7 December 2023

**VANCOUVER SPRINGS CATCHMENT AND DEVELOPMENT EXCLUSION AREA – PROPOSED DEVELOPMENT OF LOTS 1 AND 2 FRENCHMAN BAY ROAD, FRENCHMAN BAY**

**TABLE 1: RESPONSES TO DWER**

**FIGURE 1: SPRING CATCHMENT AND TOPOGRAPHY**

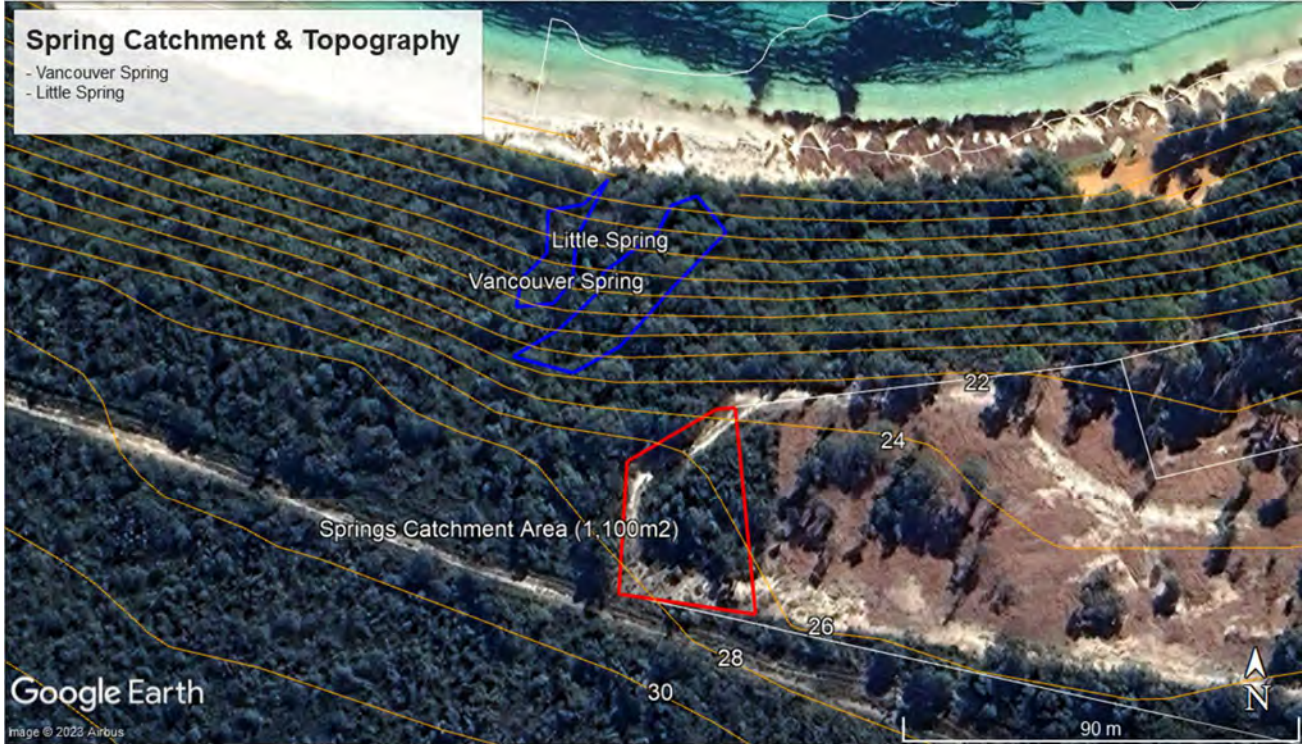
Two natural springs (Vancouver Spring and Small Spring) are located approximately 65m and 40m respectively, from the north-west corner of the Site. Under existing conditions, no surface water leaves the Site, but approximately 1,100 m<sup>2</sup> of the western corner of the Site captures ground water that flows towards the springs (Biodiverse Solutions, 2022).

The development proposal within the Vancouver and Little springs catchment includes the installation of three water tanks and vehicular emergency access.

The three proposed water tanks (two Rainchaser RC140 231,620Lt tanks and one Rainchaser RC80 122,730Lt tank; Attachment A) will contain rainwater from the roofs of the lodge, garage, alfresco and great room areas. The water will be used for potable and other uses including emergency firefighting. Although significant overflow from these systems is not expected, the water quality will be fresh and of good quality. The installation and use of the tanks poses a negligible risk to the springs, even if water overflows from the tanks. Overflow water will be directed to the access track which drains to the east of the spring catchment area.

The laneway/ emergency vehicle access area is consistent with the LDP (Attachment B) and is not considered to significantly contribute to risk of discharge to the springs. Stormwater from the paved access will be directed out of the spring catchment area to the east (Attachment C). Therefore, the minor risk of fuel spill or similar

from vehicles can be contained outside the spring catchment area in an infiltration swale. The risk of contamination from the access track is considered to be negligible.

| TITLE<br>STORMWATER MANAGEMENT PLAN |                     |                |

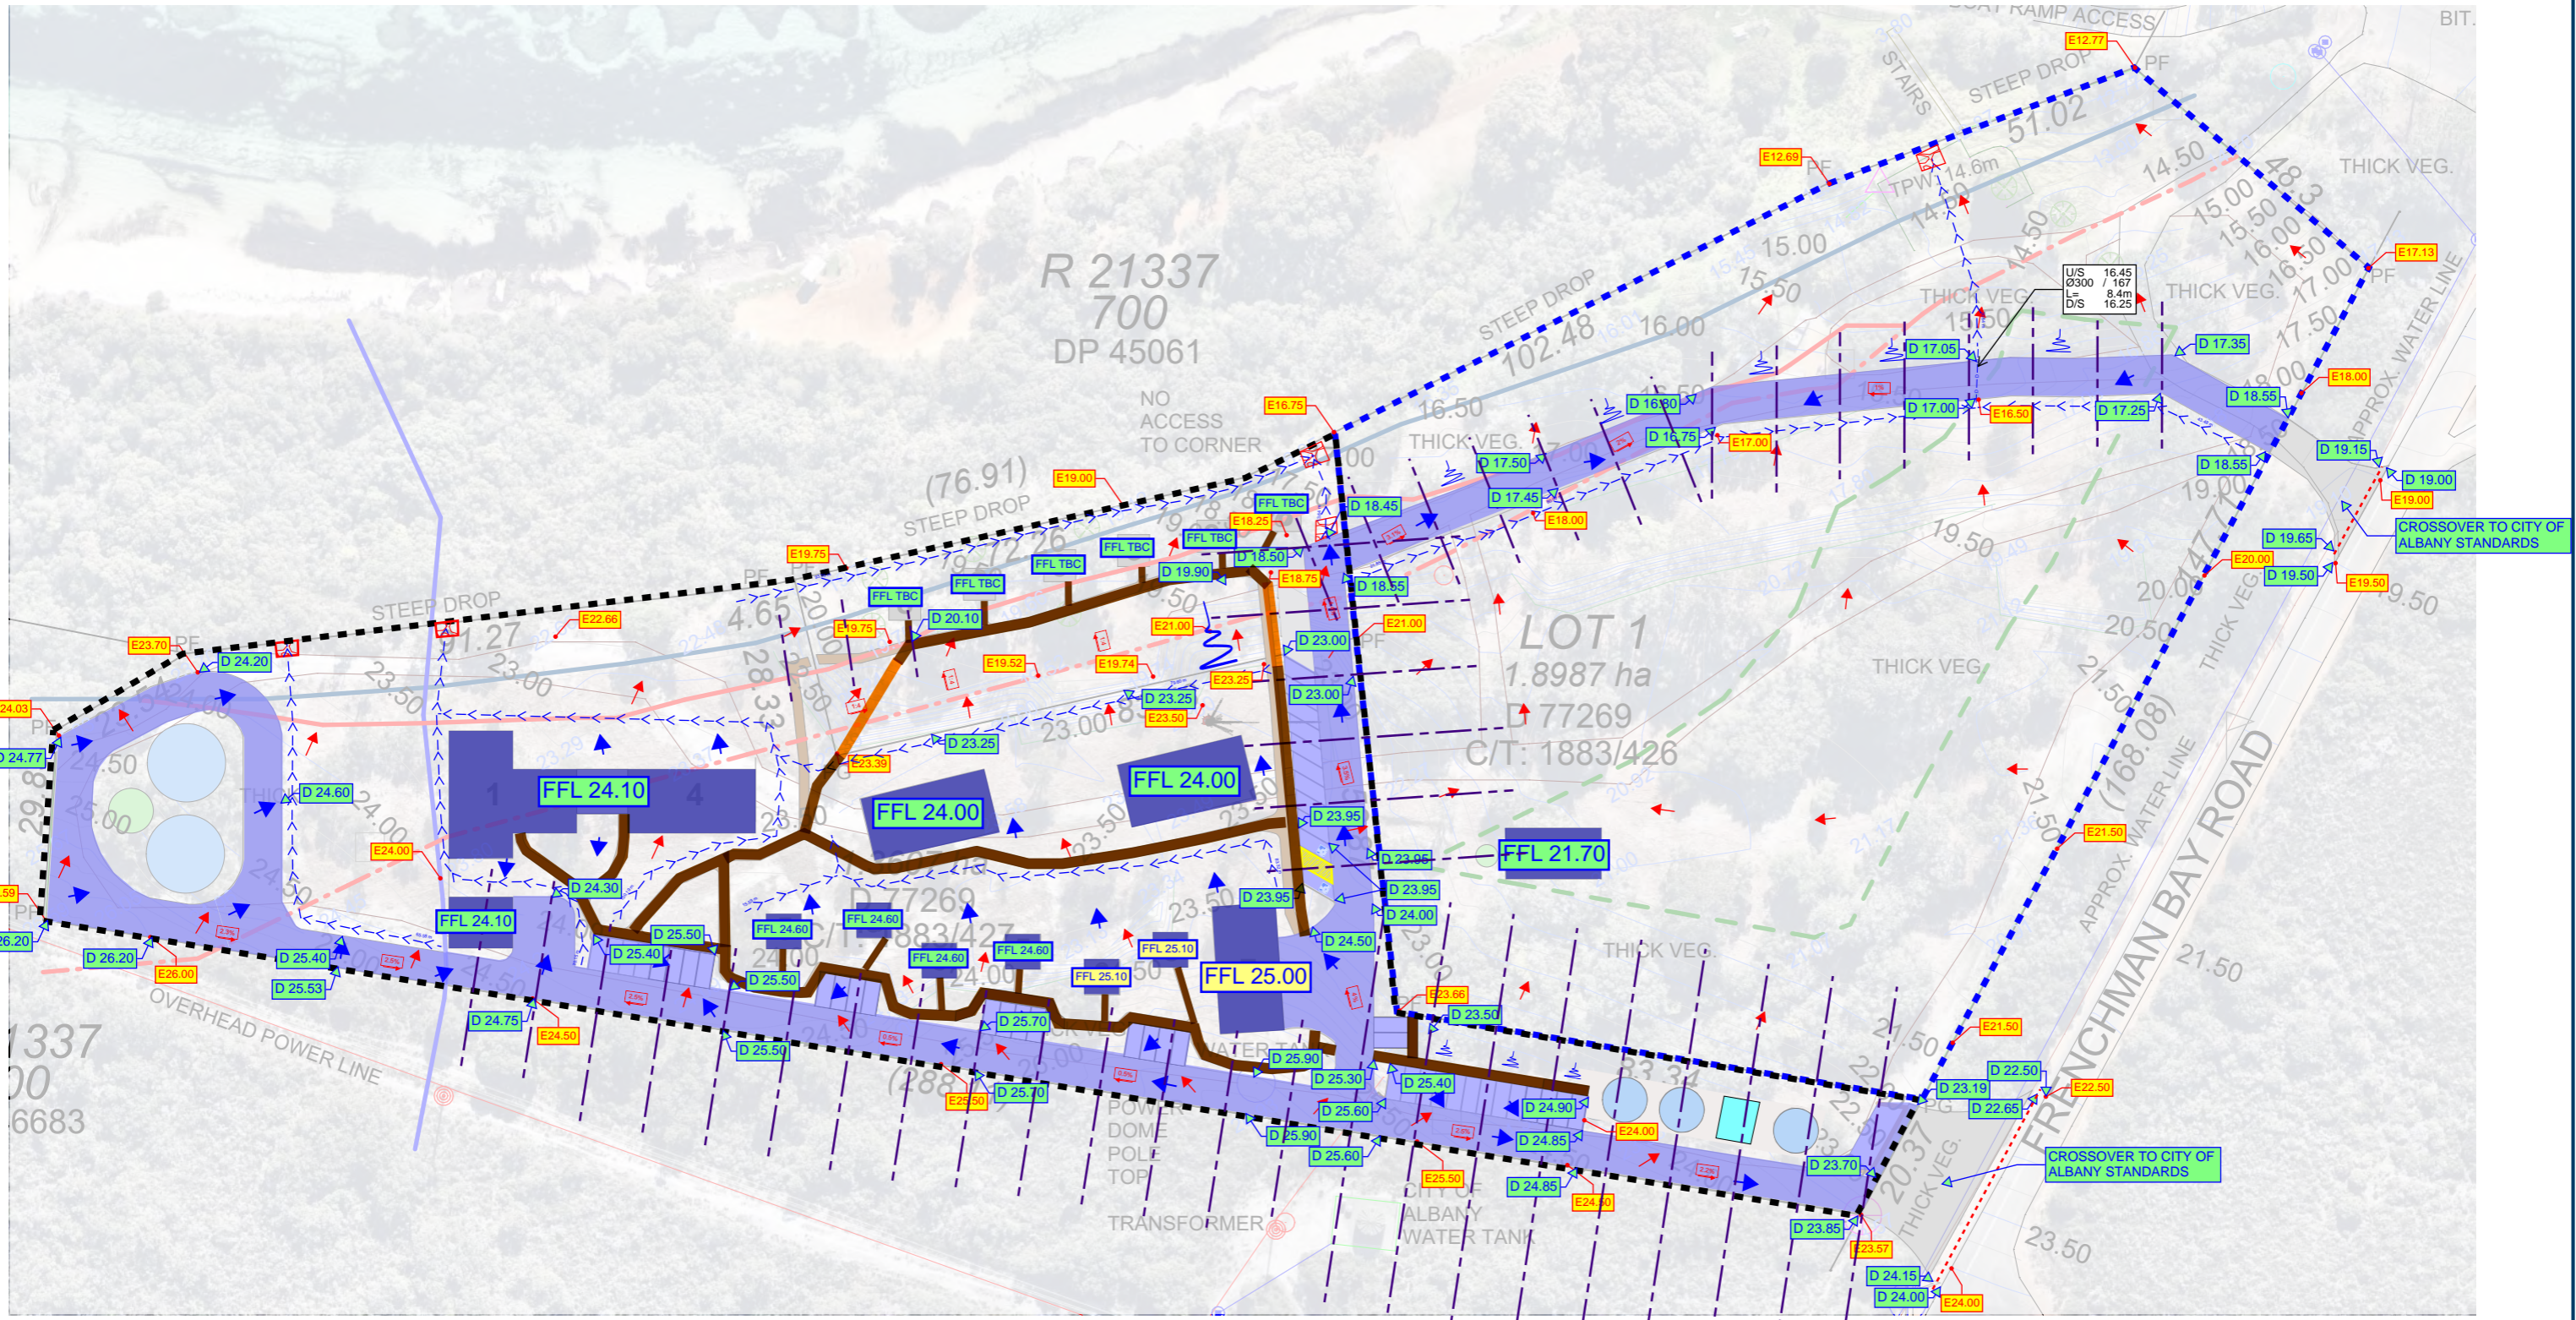
| MATTERS RAISED   | PROJECT TEAM RESPONSE  |
|--|--|
| <i>The storage capacity of the tanks should be adequate based on the catchment area. Overflow from the tanks should be collected and stored to reduce potential for run-off and erosion. Overflow from the tanks should be directed away from the springs' catchment boundary along with any stormwater run-off.</i> | The tanks have been sized to maximise storage of potable and fire fighting water. This will minimise overflow from the tanks.<br><br>Overflow from the tanks will be directed to the east, outside the springs' catchment area (Appendix C).   |
